November 16, 1978
L-78-366

Re: St. Lucie Unit No. 1
Docket No. 50-335
Proposed Amendment to
Facility Operating License DPR-67

RE: ST. LUCIE UNIT 1
DOCKET NO. 50-335
SAMPLING VALVES SAFETY EVALUATION

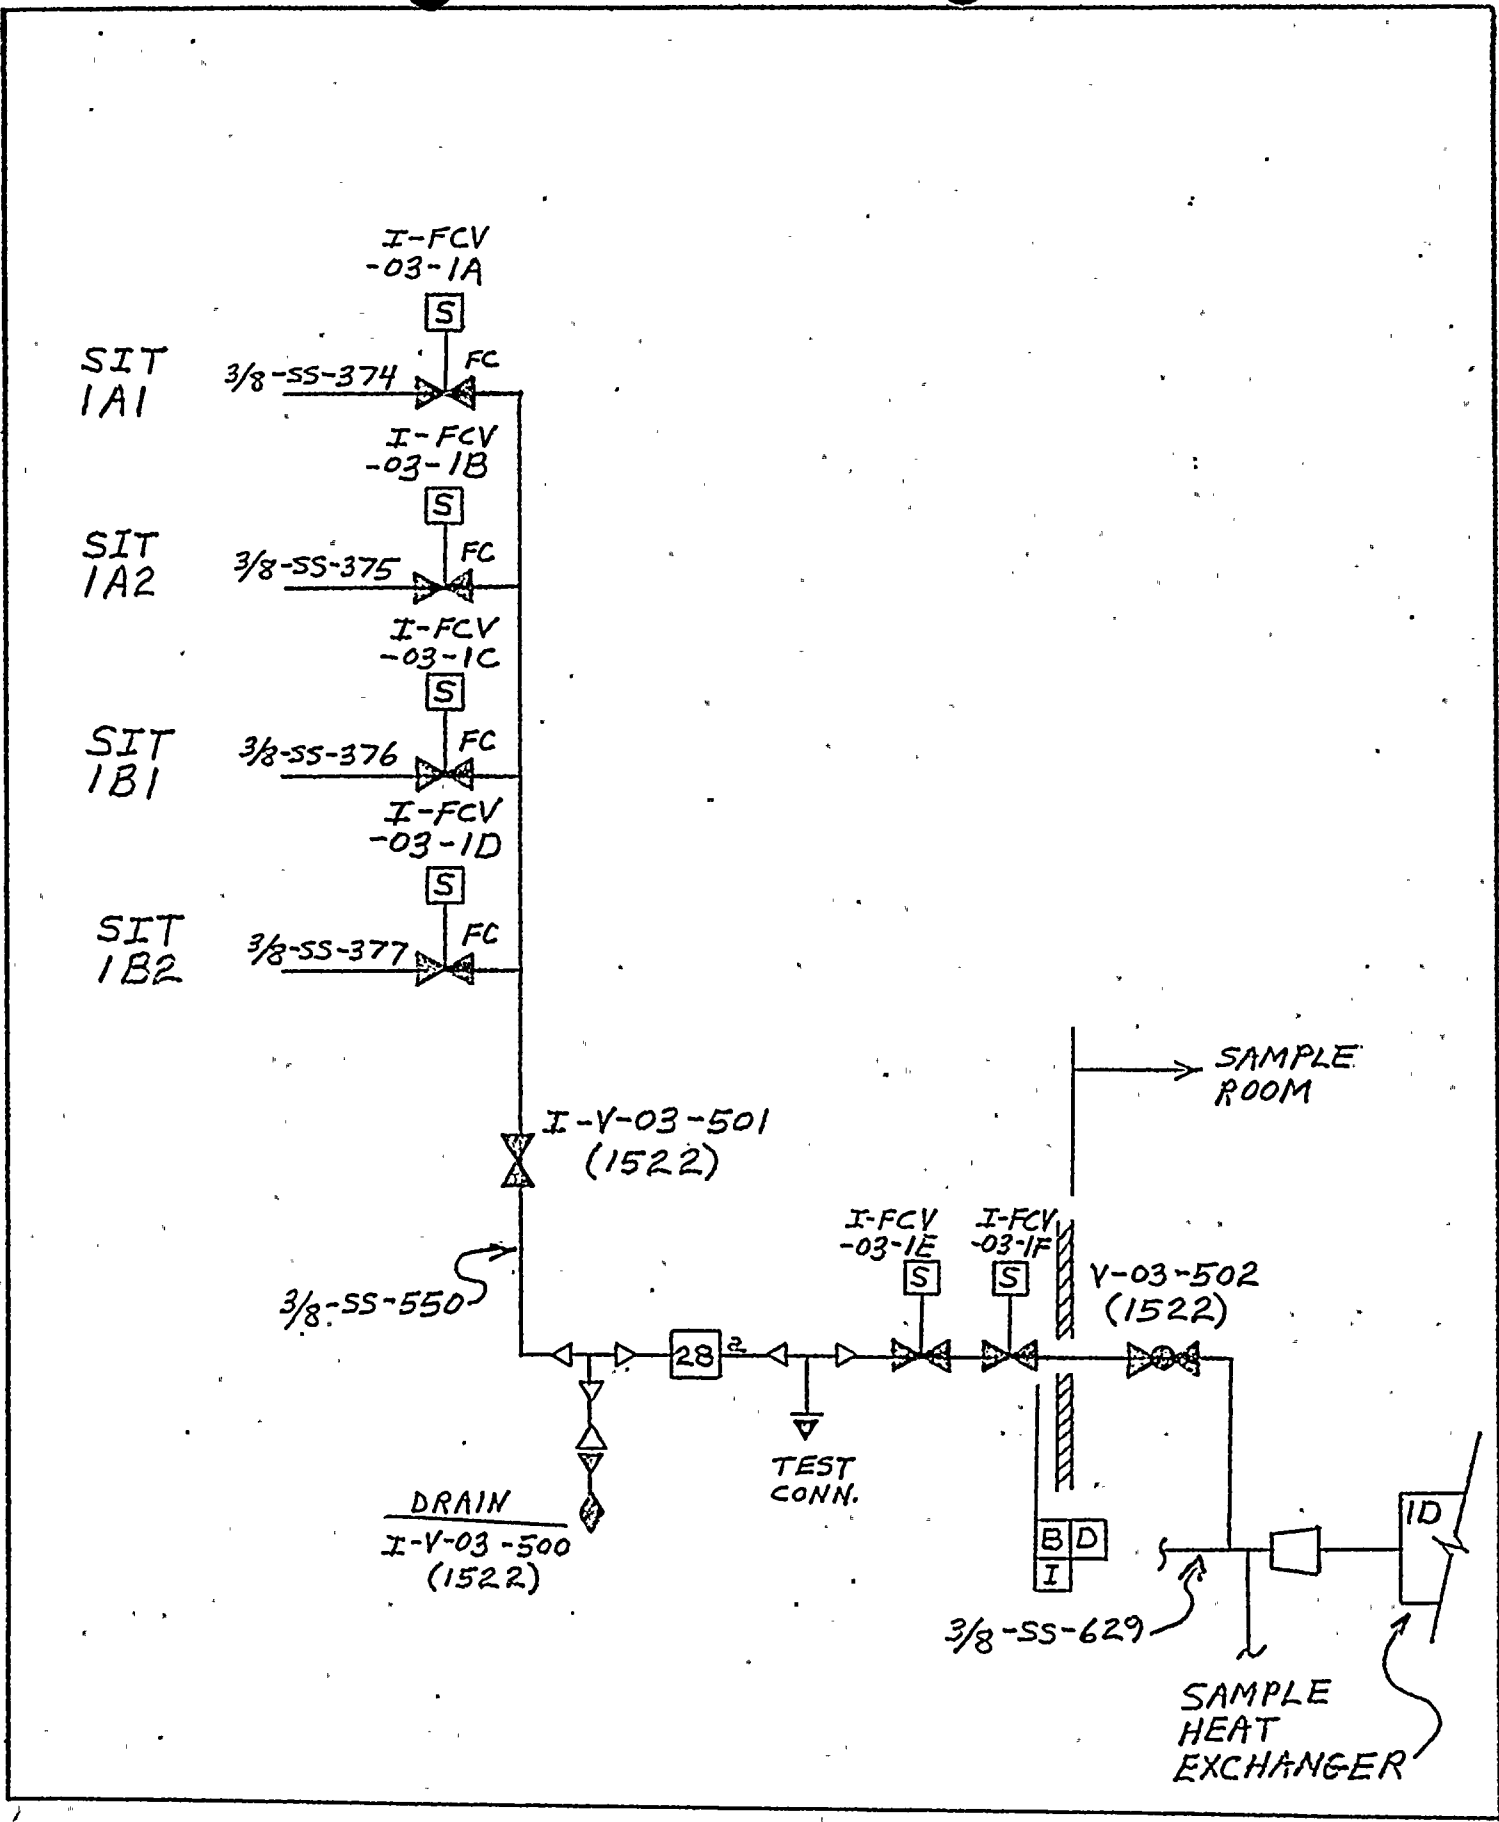
The proposed change is designed as Quality Group B, Seismic Class I and is consistent with the design criteria used in existing systems. The electrically operated containment isolation valves will be normally closed, fail closed, and will receive a containment isolation signal (CIS) to close. The CIS will override a manual attempt in the sample room to open these valves.

No single failure of the proposed system would jeopardize plant safety. A tube failure inside containment would be detected by a low level indication for one safety injection tank and/or increased flow rate to sump. The leakage rate would be less than 1.5 gpm, allowing sufficient time for operator action in accordance with the Technical Specifications. The single active failure of one containment isolation valve would be inconsequential and would not cause a leakage path since the other valve would be operable.

This change involves small diameter (3/8 inch) tubing and valves. A spare containment tubing penetration will be used.
